## TABLE OF CONTENTS

Following NRC guidance in Regulatory Guide (RG) 1.206, “Combined License Applications for Nuclear Power Plants (LWR-Edition),” and in RG 1.208, “A Performance-Based Approach to Define Site-Specific Earthquake Ground Motion,” the applicant defined the following four zones around the STP site and conducted investigations within those zones:

FSAR Section 2.5S.1 of the STP COL application includes geologic information that the applicant collected during regional and site investigations. This technical information results primarily from surface and subsurface geologic, seismic, geophysical, and geotechnical investigations performed in progressively greater detail closer to the site and within each of four circumscribed areas corresponding to site region, site vicinity, site area, and site location, as previously defined. The primary purposes for conducting these investigations are to determine the geologic and seismic suitability of the site, to provide the bases for the plant design, and to determine whether there is significant new tectonic or ground motion information that could impact the seismic design bases, as determined by a PSHA. The applicant's basic geo

**Figure 2.5.1-4. Map of Growth Faults and Growth Fault Surface Projections within the STP Site Vicinity (FSAR Figure 2.5S.1-42)**

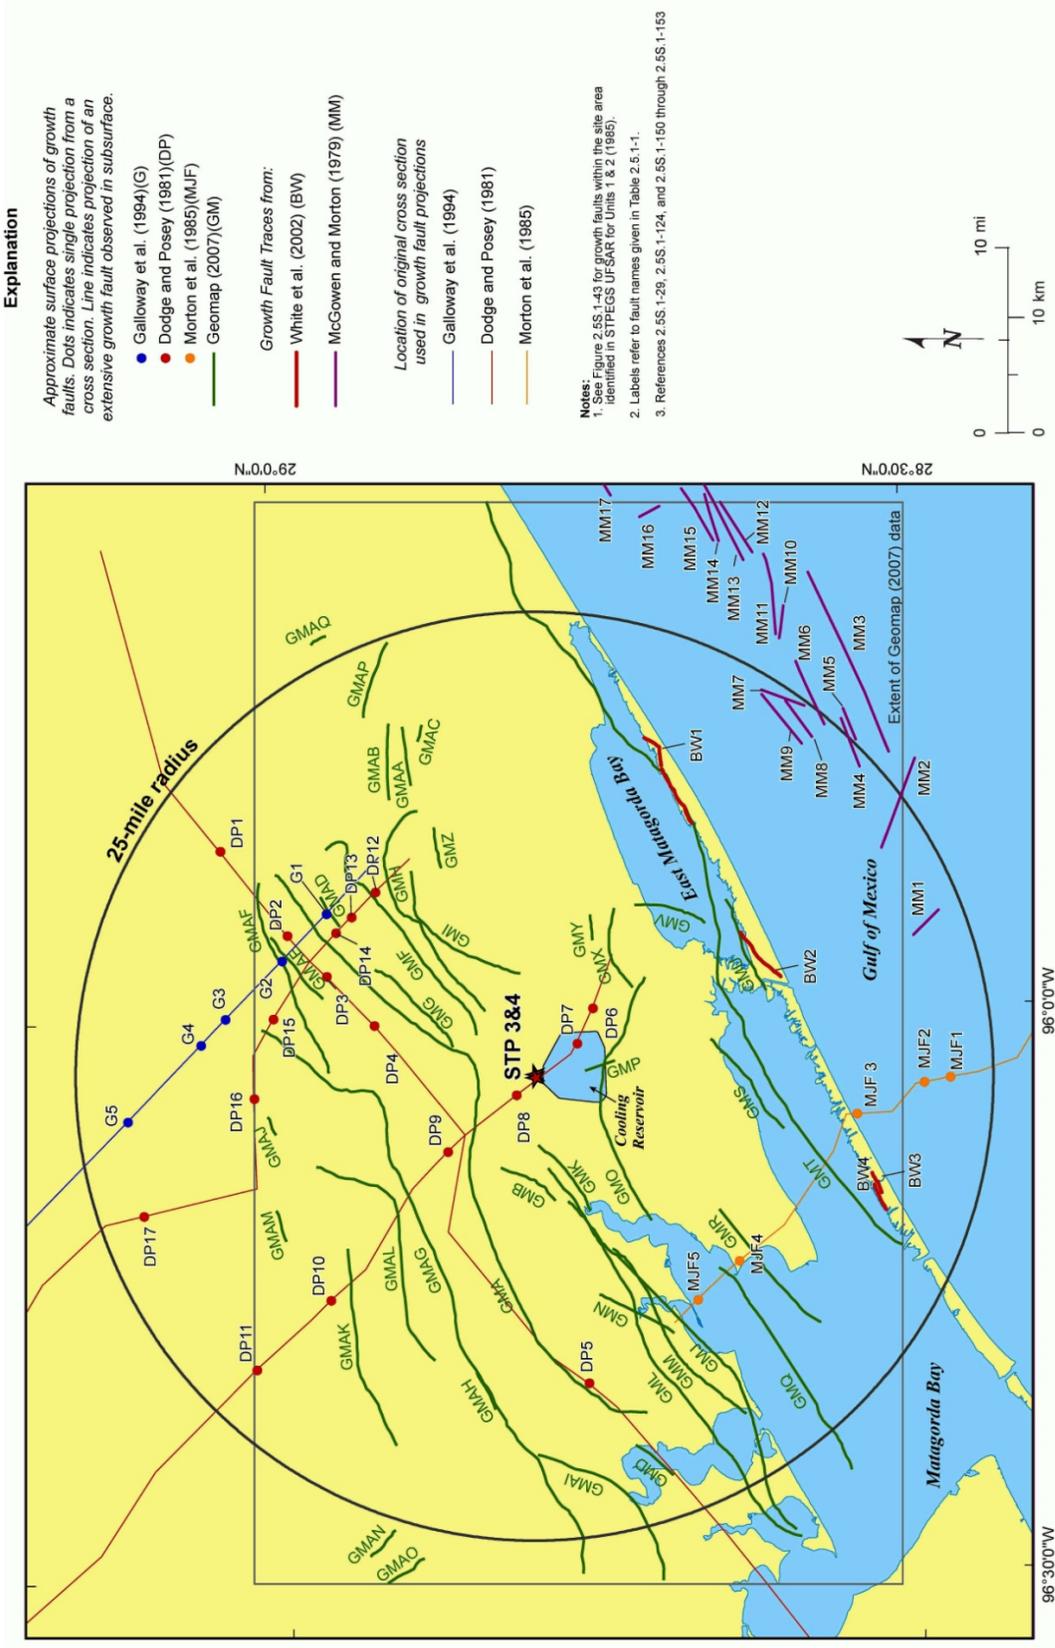
The staff issued multiple RAIs related to the applicant's evaluation of growth fault Matagorda STP12I (Matagorda GMO). In RAI 02.05.01-9, the staff asked the applicant (1) to explain why the evaluation only measured the topographic offset at four locations along the surface projection of growth fault Matagorda STP 12I (Matagorda GMO); and (2) to discuss the uncertainties in projecting this growth fault to the surface. The applicant's response to RAI 02.05.01-9 dated October 1, 2008, states that the locations of the topographic surveys (as shown in SER Figure 2.5.1-5) are based on evidence for monoclinial folding that the applicant observed during initial field reconnaissance studies. The applicant's survey did not extend beyond the westernmost observed folding but did include one location (STP L4) that was along strike with the folding and was the closest available location to the cooling reservoir. The applicant states that even though there are uncertainties in the projection of growth fault Matagorda STP 12I (Matagorda GMO), the fact that the monoclinial folding is evident in three of the four survey profiles provides confidence in the applicant's "best estimate" projection of Matagorda STP 12I (Matagorda GMO).

The staff reviewed the applicant's response to RAI 02.05.01-9. The staff concurred with the applicant's reasoning for selecting profile locations STP L1 through STP L4 based on the evidence for monoclinial folding at the surface and on the applicant's preferred surface projection for growth fault STP GMO. The applicant's response assumes that the surface projection of growth fault Matagorda STP 12I (Matagorda GMO) bends to the southeast around the cooling reservoir (as shown in SER Figures 2.5.1-4 and 2.5.1-5) rather than through the reservoir.

The staff reviewed the applicant's response to RAI 02.05.01-20 and acknowledged that the applicant has performed a robust investigation of growth fault Matagorda STP 12I/GMO based on the applicant's inferred surface projection of growth fault STP 12I/GMO. Furthermore, the staff acknowledged that the linear features identified within the cooling reservoir in SER Figure 2.5.1-5 (FSAR Figure 2.5.1-45) are now covered and therefore, the applicant cannot investigate them further. The staff concluded that the applicant's response to RAI 02.05.01-20 provides an acceptable evaluation of the projected trace of STP 12I/GMO given the lack of more convincing field observations, and the inability to further evaluate the linear features beneath the cooling reservoir. Therefore, RAI 02.05.01-9, RAI 02.05.01-10, and RAI 02.05.01-20 are closed.

Figure 2.5.1-5. Map of Growth Fault Projections, Lineaments, and Topographic Survey Points Within the STP Site Area (Reproduced from FSAR Figure 2.5S.1-45)

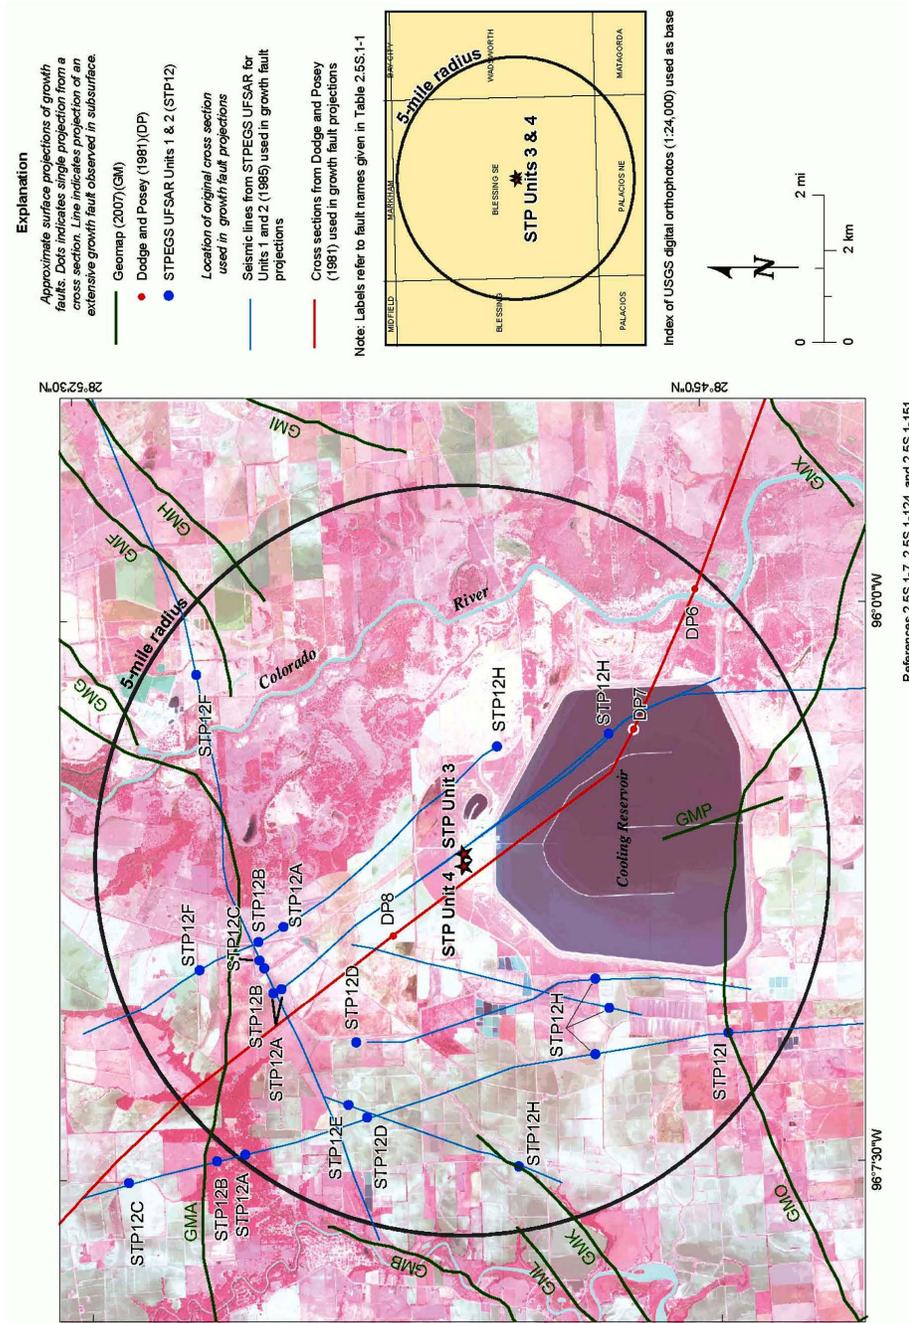
Given that seismic reflection, well log, and imagery data sources described in FSAR Subsection 2.5S.1.2.4.2.2 could not resolve surface locations of growth faults in the STP site area, the staff issued RAI 02.05.01-8 requesting the applicant to explain why the investigations for the STP COL application site do not include a light detection and ranging (LiDAR) survey of the site area to reassess evidence for possible subtle surface folding or faulting along growth faults. The applicant’s response to RAI 02.05.01-8 dated July 16, 2008 (ML082030326), updates FSAR Figures 2.5S.1-44 and 2.5S.1-45 to include the locations of all “anomalous geomorphic features” that might indicate surficial deformation due to growth faulting. The applicant states that growth fault Matagorda STP12I (Matagorda GMO) is the only growth fault that could be correlated with linear geomorphic features identified in the applicant’s aerial photographic analysis. Therefore, it is “the only fault within the site area with a geomorphic expression of potential Quaternary activity.” With regard to applying other methods such as the LiDAR to investigate potential surface displacements, the applicant states the following:

As presented in Subsection 2.5S.1.2.4.2.2 and apparent in Figure 2.5S.1-45, the monoclinical folding, lineations, and surface projections associated with fault I/GMO are strongly correlated, suggesting that the diversity of methods used to identify growth faults with surface expression (e.g., ground reconnaissance, fault

The staff reviewed the applicant's response to RAI 02.05.01-8, including enhanced FSAR Figures 2.5S.1-44 and 2.5S.1-45, and acknowledged that the applicant has adequately identified a range of geomorphic features using available satellite imagery and aerial photographic data. In addition, the staff noted that the applicant has performed additional investigations of potential surficial features as part of aerial and field reconnaissance efforts.

Figure 2.5.4-1. Shear Wave Velocity Profile of Strata A to J (FSAR Figure 2.5S.4-45)

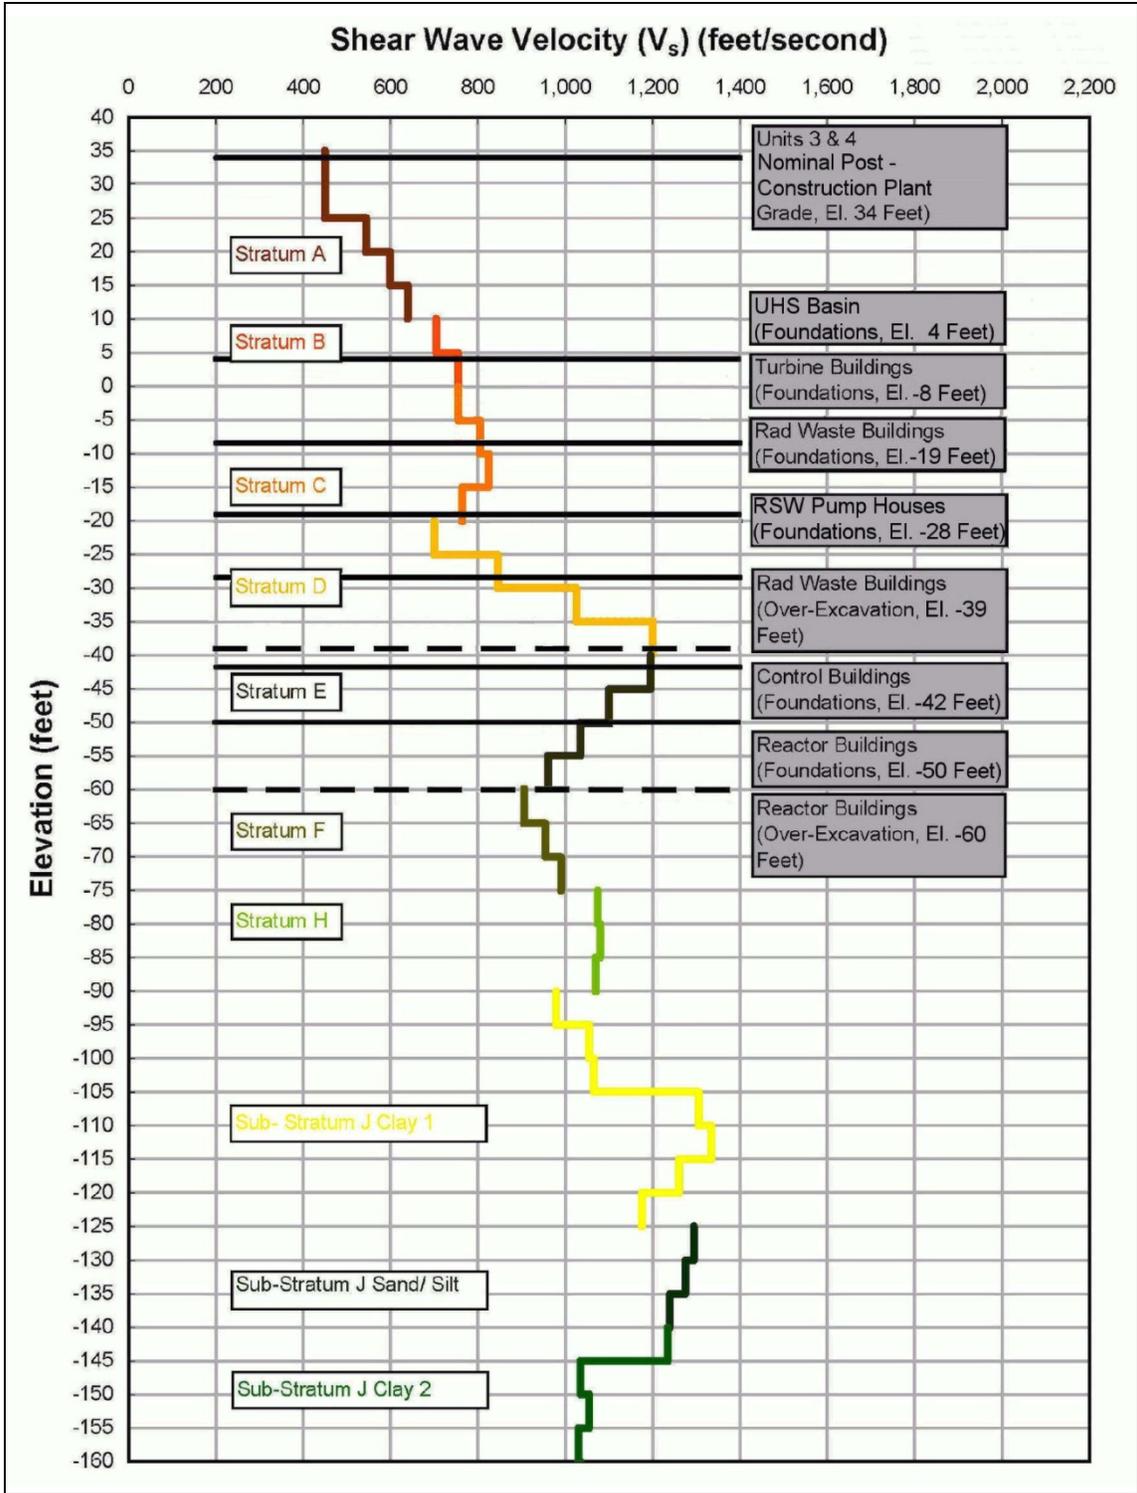
Although the ABWR DCD specifies a minimum shear wave velocity of 304 m/s (1,000 fps), FSAR Figures 2.5S.4-39 through 2.5S.4-44 show soil profiles with a shear wave velocity of less than 304 m/s (1,000 fps). NRC staff issued RAI 02.05.04-12 requesting the applicant to discuss the shear wave velocities for the site with respect to the ABWR DCD Tier 1 criteria.
